Author response to the referee comments

egusphere-2026-3951. *How exposed is a mountain road to snow avalanches? A corridor-scale assessment in the southern Andes.* Iván Latorre, Marius Schaefer and Felix Oesterle.

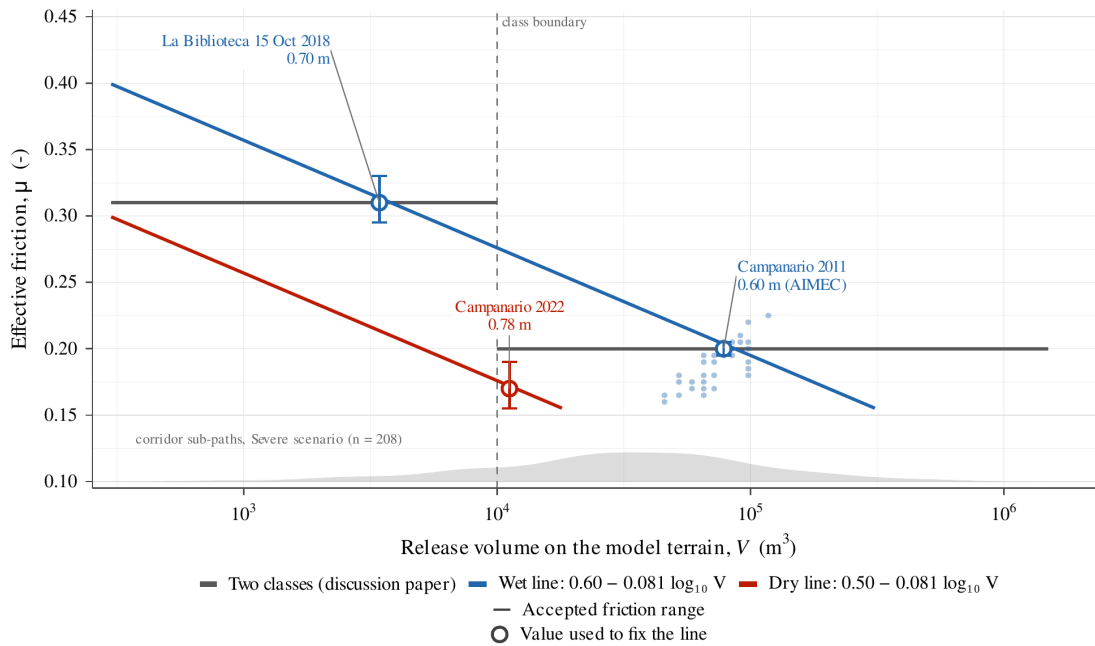
"First, the second Campanario avalanche with a volume of 9,100 m³ [...] falls below the proposed threshold of 10,000 m³, so it should be simulated with $\mu = 0.31$ according to the authors' recipe. Second, it is well known that dry-snow avalanches can have significantly lower friction than wet-snow ones of comparable volume. Third, an abrupt increase of μ by 0.11 at the transition from 'large' to 'small' avalanches is not physically plausible [...]"

These three objections are valid. We will use the referee's proposed form, $\mu = a - d \log_{10} V$, for a smooth law with separate wet and dry lines, replacing the two-class scheme; V is release volume (m³) on the model terrain. As the referee envisaged, we calibrated the constants from our events instead of using his tentative values. We used documented fracture depths except for Campanario 2011, where no observation was available. Among runs meeting the criteria in #19, AIMEC selected 0.60 m as the best match to the mapped deposit. Denser sweeps (μ increments of 0.005) identified friction compatible with observations at these depths. We passed the wet line through the best-constrained calibration on each path: La Biblioteca, 15 October 2018 ($\mu = 0.31$; 3 430 m³; accepted range 0.295 to 0.33), and Campanario 2011 ($\mu = 0.20$; 78 400 m³; 0.195 to 0.205). These were the discussion paper's two calibrated values and gave $\mu_{\text{wet}} = 0.60 - 0.081 \log_{10} V$. Agreement with the 7 October 2018 event (0.31; accepted range 0.275 to 0.41) provided a further check: the event crossed the road, but its runout beyond the crossing was unobserved. One dry event could determine only the dry line's level. We retained the wet line's slope and passed the dry line through Campanario 2022 (0.17 at the 0.78 m fracture depth from the snow pit; accepted range 0.155 to 0.19): $\mu_{\text{dry}} = 0.50 - 0.081 \log_{10} V$. Both lines were truncated at the lower bound $\mu = 0.155$, the standard value for extreme dry avalanches above about 1 300 m (Buser and Frutiger, 1980; Salm et al., 1990). This bound was reached at about 18 000 m³ on the dry line and 310 000 m³ on the wet line (Fig. R1). The slope was consistent with Swiss practice: the dry-snow volume classes of Gruber and Bartelt (2007) imply about 0.05 to 0.09 per tenfold increase in volume. The unobserved 2011 release volume nevertheless left it poorly constrained: the depths that AIMEC matched to the mapped deposit (0.50 to 0.90 m) yielded slopes from 0.055 to 0.10. For comparison, the constants tentatively suggested by the referee (0.50, 0.44 and 0.06) gave similar friction over 3 000 to 80 000 m³ and nearly identical corridor results (510 versus 507 road-reaching simulations with the wet line). We then simulated the 208 release areas under all three scenarios with each calibrated line (Fig. R2):

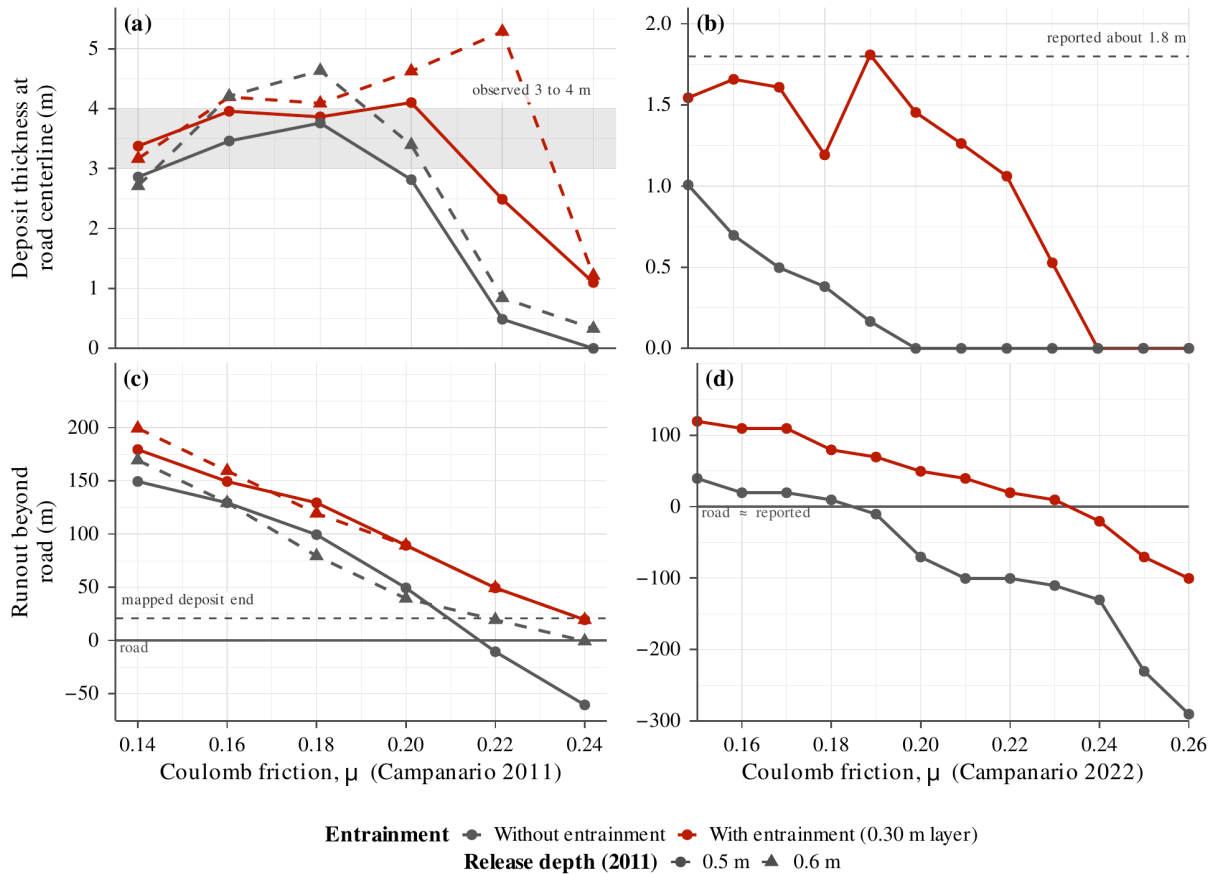
R2.7 *"The neglect of entrainment is, in my view, a major physical limitation rather than a secondary caveat." and "[...] the apparent difference between $\mu \approx 0.20$ and $\mu \approx 0.31$ could be influenced not only by volume and path geometry but also by very different opportunities for mass entrainment."*

We agree that omitting entrainment was a major physical limitation. To assess its influence, we used the entrainment option in com1DFA. We lacked observations to constrain erodible snow on these paths, so we specified an erodible layer of uniform thickness, 0.30 m, excluding release areas, and used an entrained density of 200 kg m^{-3} with default erosion parameters. Over steep rock, this assumption tends to overestimate entrainment. The comparison yielded the following results (Fig. R3):

- For Campanario 2011, simulated entrainment added roughly half as much mass as was released. This likely overestimated the actual contribution because snow may not have covered the entire lower path. Landsat imagery nine days before the October event showed snow cover extending down the path past the road; a week after the event, slopes below about 1 800 m appeared largely bare. To reproduce observed runout, friction had to increase by 0.02 to 0.03; a lower release volume could have yielded the observed deposit. These results illustrated the referee's point about the trade-off among release volume, friction and entrained mass.

- For the small event in 2022, the mass entrained was 1.4 to 1.7 times that released; without entrainment, we could not reproduce the reported deposit (R2.4).

- The short La Biblioteca paths entrained less than 7 % of the released mass, and calibrated friction shifted by under 0.01. Thus, entrainment explained only a minor part of the difference between the two path calibrations.
